ADDENDUM NO. 1

Natomas Levee Improvement Program

**ELDERBERRY SHRUB & VALLEY OAK RELOCATION/TRANSPLANTING
RM 0.5 and SREL Reaches 19-20**

Date: May 1, 2014

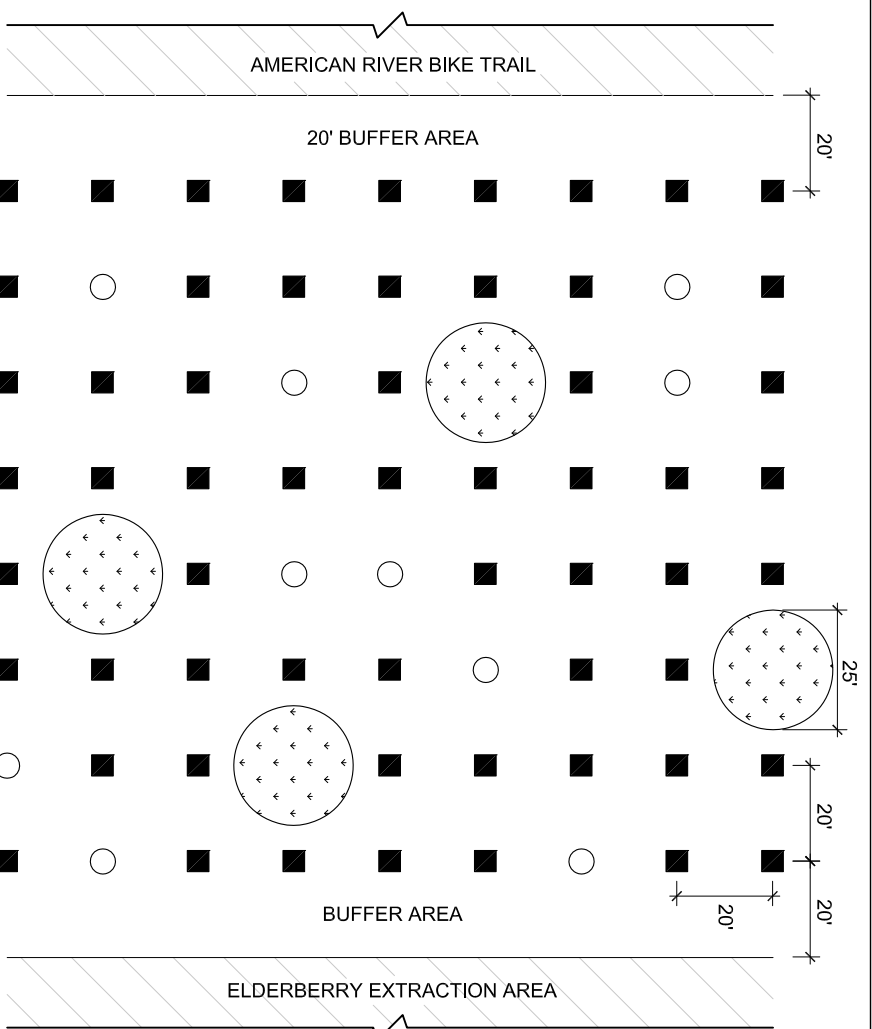
Add: 3.4 GUYING/STAKING TREES

Guying and staking of trees shall be implemented on trees greater than 10 inches in diameter at breast height (DBH) to reduce the chance of blow-over. Guying methods used shall be generally consistent as indicated in the narrative and diagram below:

A minimum of three (3) guy wires shall be used. When staking trees, ensure the top of the tree is free to move with the wind. Use a broad bandage, fabric strap or run guy wires through rubber garden hose and strap the tree at the lowest branch crotches. Make loops around the branches/trunk very loose to avoid damaging the tree. All guy wires shall be tightened so they are taut utilizing turnbuckles. Anchoring systems shall be low to the ground and located outside of the watering basin. Trees between 10 and 14 inches DBH shall be anchored utilizing an earth anchoring device such as a metal vineyard stake or similar method. Metal stakes shall be a

minimum of 12 gauge and be at least 30 inches long and driven into the ground on a 30-45 degree angle toward the center of the tree. Guy wires shall be 3/16 inch cable and attached and or wrapped/clamped to the anchor device/method used. Turnbuckles shall be sized to accommodate the weight loading of the cable. As a safety precaution, a 1 inch diameter by 4 length of white pvc piping shall be placed around each guy wire so it is clearly visible to the naked eye.

EXHIBIT B

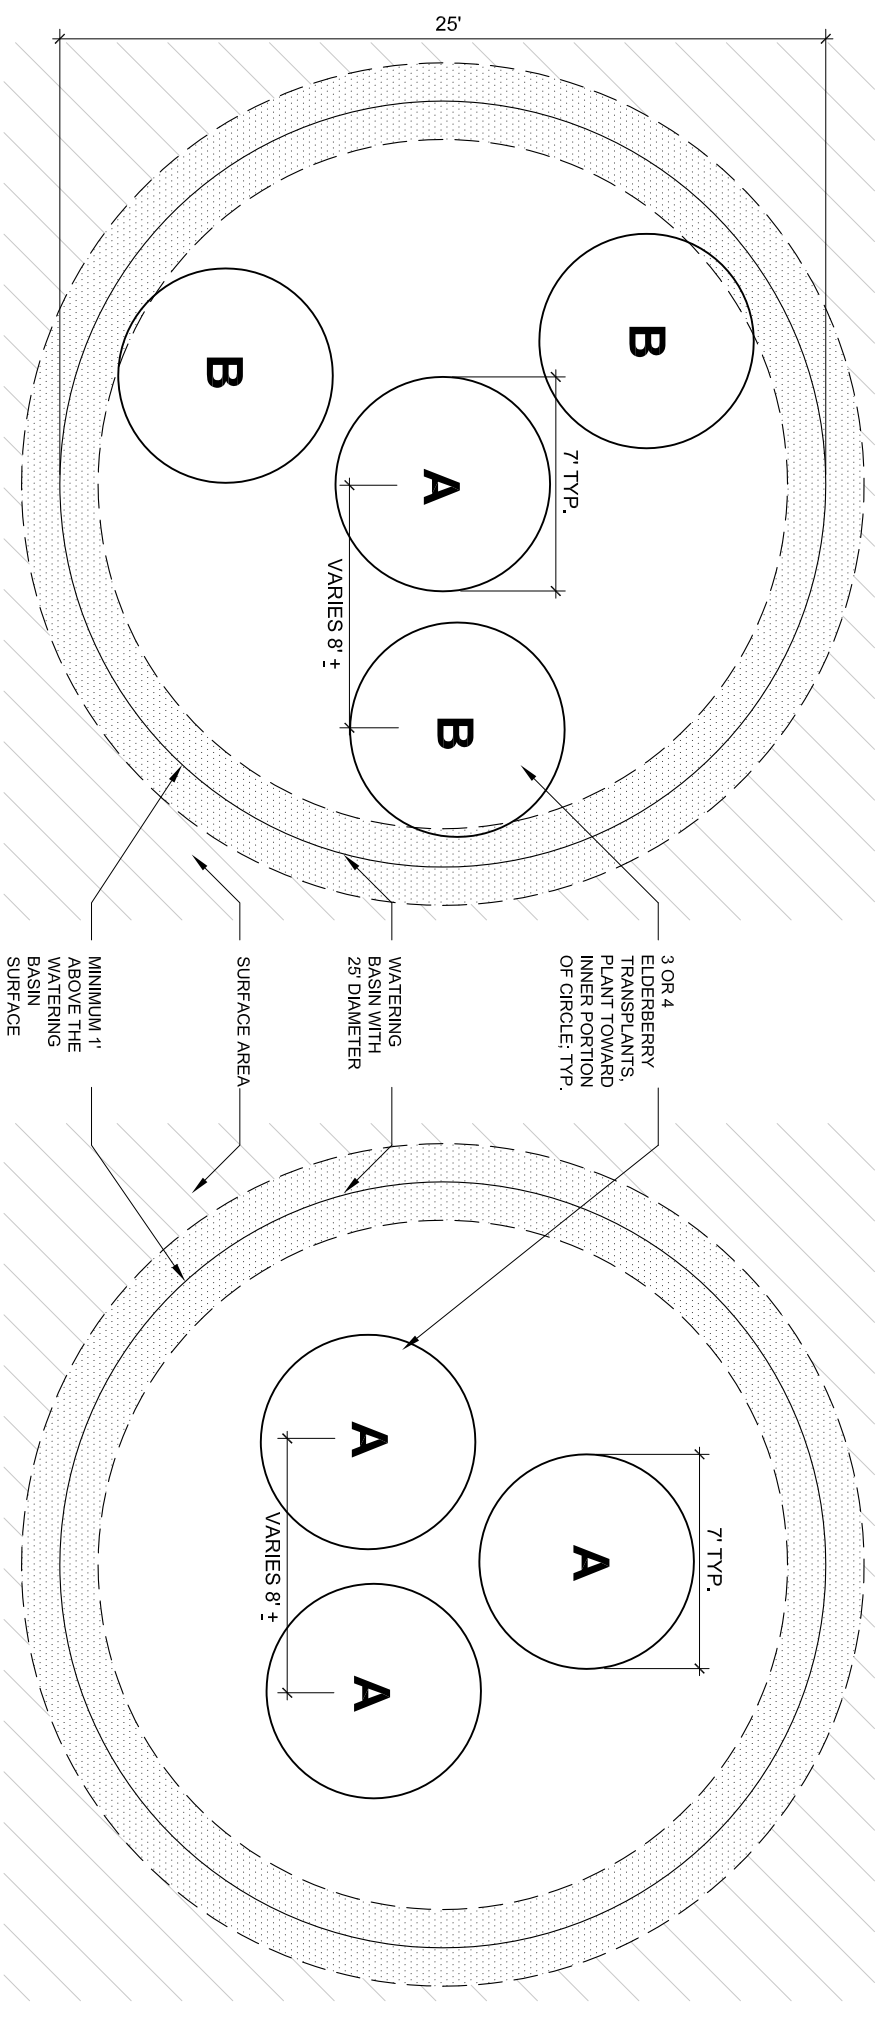
Add: 3.5 ELDERBERRY TRANSPLANT LAYOUTS

A schematic which illustrates the preferred elderberry transplant layout is attached to this addendum. All elderberry shrubs shall be transplanted according to this layout.

- NOTES:**
- SEE EXHIBIT A, FOR ELDERBERRY TRANSPLANTS AREA.
 - PLANT TYPES TO BE LOCATED RANDOMLY WITH 20' O.C. SPACING WITH AGENCY APPROVAL.
 - BUFFER WIDTH OF 20' SHALL BE PROVIDED ALONG AMERICAN RIVER BIKE PATH.
 - A 20' FOOT WIDE BUFFER AREA SHALL BE PROVIDED BETWEEN THE ELDERBERRY TRANSPLANTS AREA AND ELDERBERRY EXTRACTION AREA.
 - ELDERBERRY TRANSPLANT CLUSTERS SHALL BE PLACED A MINIMUM OF 40' O.C. FROM EACH OTHER.
 - DIAGRAMMATIC LAYOUT WIDTHS OF ELDERBERRY TRANSPLANTS WILL VARY.

- NOTES:**
- ELDERBERRY TRANSPLANTS SHALL BE LOCATED TOWARD THE INNER PORTION OF THE PLANTING CIRCLE.
 - THE NUMBER OF TRANSPLANTS PER CLUSTER SHALL VARY DEPENDING ON THE SIZE OF THE ELDERBERRY TRANSPLANT. NO MORE THAN 3 LARGE ELDERBERRY TRANSPLANTS SHALL BE PLANTED IN ONE CLUSTER.
 - ASSUME 90° TREE SPADE WILL BE USED TO TRANSPLANT ELDERBERRIES.

A = SHALL BE LARGER TRANSPLANTS RELOCATED
B = SHALL BE SMALLER TRANSPLANTS RELOCATED
